**General Information**  
(see reverse for instructions)

<b>Name of Project</b>	Franklin Hills Estates & Country Club	<b>CGP Tracking No.</b>	IR #21-7	<b>Inspection Date</b>	3/29/2021
<b>Inspector Name, Title &amp; Contact Information</b>	Inspector: David McKay, P.E.		Reviewer: David McKay, P.E.		
<b>Present Phase of Construction</b>	Phase 1				
<b>Inspection Location</b> (if multiple inspections are required, specify location where this inspection is being conducted)	Areas of Concern as defined at site walk with wetlands commission.				
<p><b>Inspection Frequency</b> (Note: you may be subject to different inspection frequencies in different areas of the site. Check all that apply.)</p> <p><b>Standard Frequency:</b>   <input type="checkbox"/> Weekly      <input type="checkbox"/> within 24 hours of a 0.5" rain</p> <p><b>Increased Frequency:</b>   <input type="checkbox"/> Every 7 days and within 24 hours of a 0.5" rain (for areas of sites discharging to sediment or nutrient-impaired waters or to waters designated as Tier 2, Tier 2.5, or Tier 3)</p> <p><b>Reduced Frequency:</b></p> <ul style="list-style-type: none"> <li>- <input type="checkbox"/> Once per month (for stabilized areas)

Photo 1: Stone check dam immediately upgradient of main entry water crossing is in good condition. Some off-road vehicles have started to damage the check dams, but ample capacity is still available.

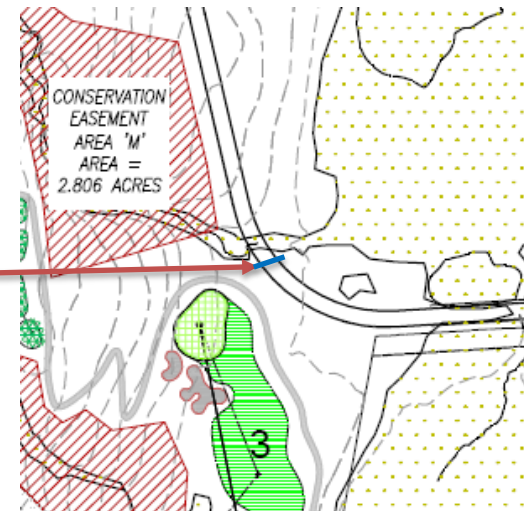
1. Main Entry Water Crossing (Northerly of 3 <sup>rd</sup> Hole Green)	<input type="checkbox"/> Yes <input checked="" type="checkbox"/> No	<input type="checkbox"/> Yes <input checked="" type="checkbox"/> No		Stone check dam immediately upgradient of crossing has ample storage capacity (Photo 1). Stone check dam in trail leading down to crossing has ample storage capacity (Photo 2). Some off-road vehicles have started to damage the check dams, but ample capacity is still available.

Photo 3: Sediment fence has been repaired and reinforced with stone check dams and is in good condition.

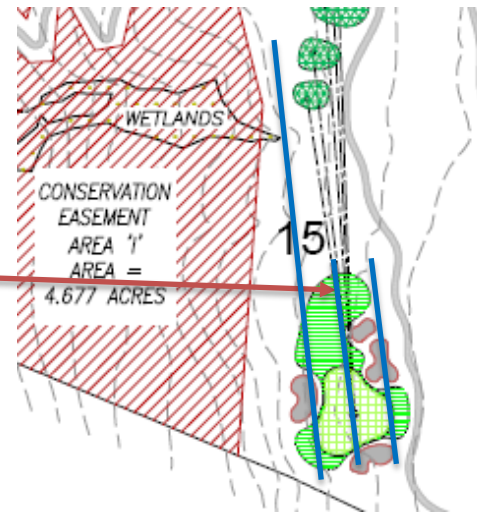
2. 15 <sup>th</sup> Green Sediment Barriers	<input type="checkbox"/> Yes <input checked="" type="checkbox"/> No	<input type="checkbox"/> Yes <input checked="" type="checkbox"/> No		Downgradient stone check dam remains in good condition. Sediment fence along the cart path and along the tree line are in good condition. Intermediate sediment fence has been re-staked. (Photo 3). Sediment fence rows and staked hay bales in south end have been repaired and eroded area has been stabilized with stone. (Photo 4).

Photo 5: Filtered flow along 15<sup>th</sup> fairway at stone check dams and perimeter sediment fence.

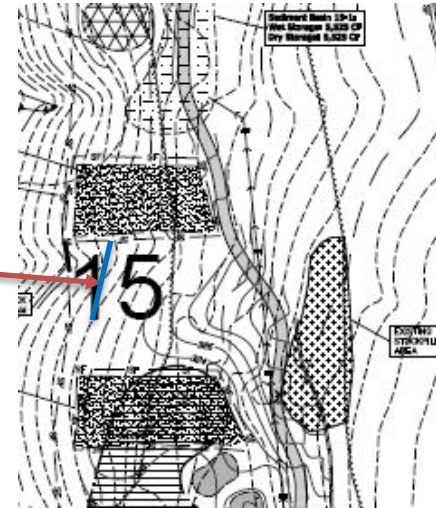
3. 15 <sup>th</sup> Fairway Sediment Barriers	<input type="checkbox"/> Yes <input checked="" type="checkbox"/> No	<input type="checkbox"/> Yes <input checked="" type="checkbox"/> No		Stone check dams, stone apron are in good condition and functioning as intended. (Photo 5).

3. 15 <sup>th</sup> Hole Fairway	Plans – Silt fence and stone check dam Existing – Series of stone check dams and silt fence at limits of wooded area to the west	<input checked="" type="checkbox"/> Yes <input type="checkbox"/> No <input type="checkbox"/> N/A	Stone check dams and apron are in good condition and functioning as intended. Clear flow was observed passing through the check dams.

Photo 6: No signs of erosion in swale at entrance driveway.

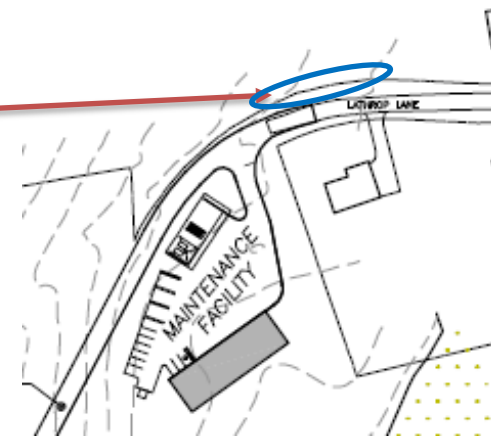
4. Construction Entrance (Westerly of Proposed Maintenance Road)	<input type="checkbox"/> Yes <input checked="" type="checkbox"/> No	<input type="checkbox"/> Yes <input checked="" type="checkbox"/> No		Stone check dam and water bar across construction entrance are in good condition and functioning as intended (Photo 6). Diversion swale excavated to downgradient drainage structure does not show signs of erosion. Stone check dams should be added to new swale if erosion occurs.

Stabilization Area	Stabilization Method	Have You Initiated Stabilization?	Notes
1. Construction Access Drive	Plans - Anti-tracking pad Existing - Water bar at site entrance	<input checked="" type="checkbox"/> Yes <input type="checkbox"/> No <input type="checkbox"/> N/A	There was no flow in the swale during the inspection with no evidence of erosion. Add stone check dams to swale if erosion occurs.

Photo 7: Stone check dams and sediment fence across the 7<sup>th</sup> hole fairway hillside are in good condition, filtered flow observed.

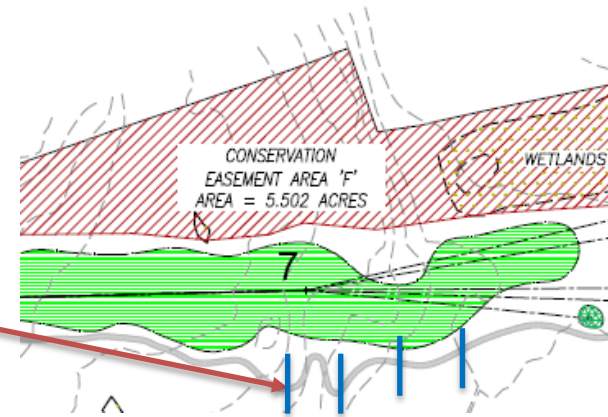
5. 7 <sup>th</sup> Hole Fairway Hillside	<input type="checkbox"/> Yes <input checked="" type="checkbox"/> No	<input type="checkbox"/> Yes <input checked="" type="checkbox"/> No		Check dams across 7 <sup>th</sup> Hole fairway are in good condition overall and functioning as intended (Photo 7). Clear flow was observed passing through the check dams.

2. 7 <sup>th</sup> Hole Fairway Hillside	Plans – Multiple rows of silt fence Existing – Series of stone check dams and silt fence	<input checked="" type="checkbox"/> Yes <input type="checkbox"/> No <input type="checkbox"/> N/A	Area is stabilized at this time. Stone check dams are in good condition and are functioning as intended. Clear flow was observed passing through the check dams.

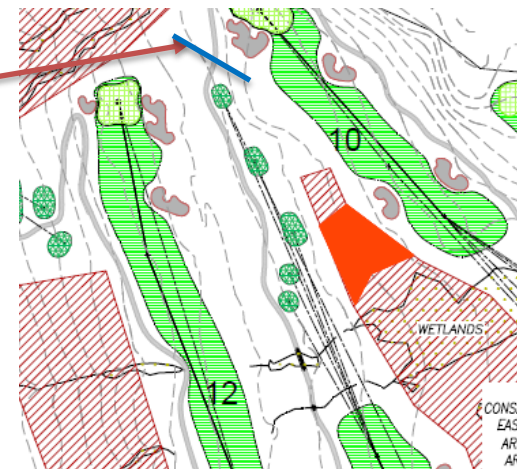
6. 11 <sup>th</sup> Hole Tee Box Area	<input type="checkbox"/> Yes <input checked="" type="checkbox"/> No	<input type="checkbox"/> Yes <input checked="" type="checkbox"/> No		Sediment fence row across path by 11 <sup>th</sup> Hole tee box and hay bale check dam are in good condition (Photo 8). Stone check dam has ample storage capacity. Some off-road vehicles have started to damage the hay bales, but ample capacity is still available.

4. 11 <sup>th</sup> Hole Tee Box Area	Plans – Silt fence and diversion channel Existing – Single row of silt fence across path and one stone check dam	<input checked="" type="checkbox"/> Yes <input type="checkbox"/> No <input type="checkbox"/> N/A	Sediment fence, hay bale check dam and stone check dam are in good condition. Some off-road vehicles have started to damage the hay bales, but ample capacity is still available.

Photo 9: Sediment fence has been repaired and additional stone check dams added to disrupt flows. Measures are in good condition and flow is filtered by stone check dams.

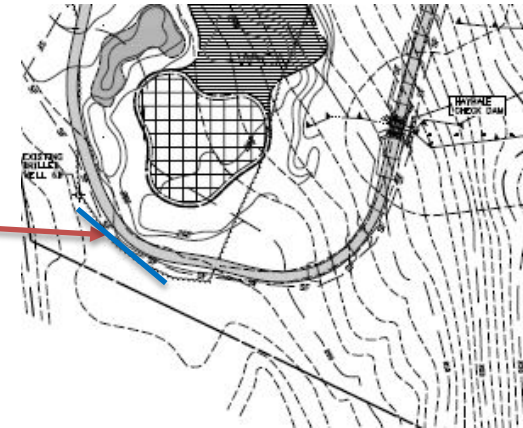
7. 14 <sup>th</sup> Hole Green Sediment Barriers	<input type="checkbox"/> Yes <input checked="" type="checkbox"/> No	<input type="checkbox"/> Yes <input checked="" type="checkbox"/> No		Additional stone check dams and sediment fence are in good condition (Photo 9).

Photo 10: Clear flow from wetlands outlet.

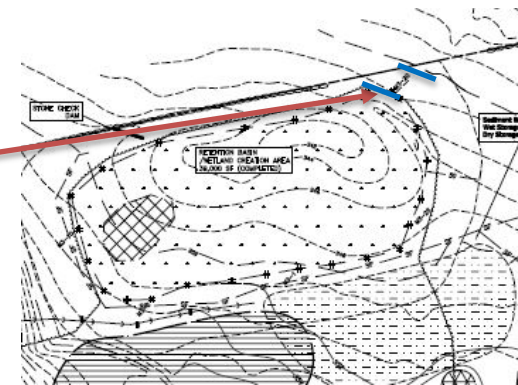
8. Created Wetlands Outlet	<input type="checkbox"/> Yes <input checked="" type="checkbox"/> No	<input type="checkbox"/> Yes <input checked="" type="checkbox"/> No		No repairs required. Discharge from wetlands was flowing clear (Photo 10).
